SPEAKERPHONE SYSTEM—3-TYPE

752-TYPE TELEPHONE SETS

CONNECTIONS AND MAINTENANCE

1.02 This section is reissued to:

Fig. 1—Speakerphone Components

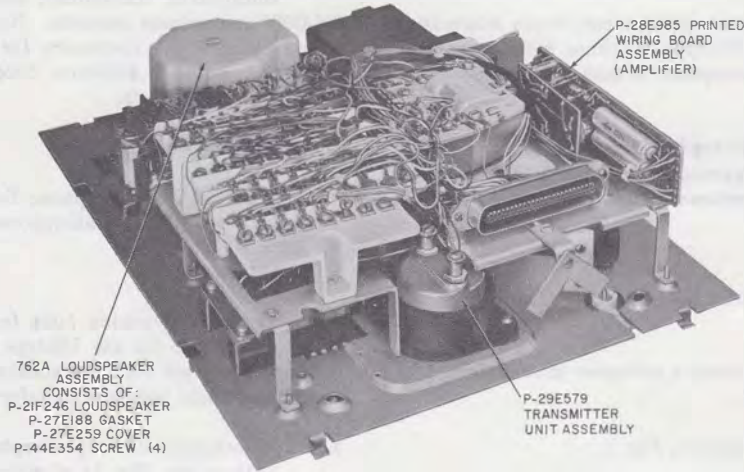
- Change section reference in read note, 1.03, and 3.01.
- Change callout, Fig. 1.
- Add 55A (MD) and 55A* control unit, Fig. 2.
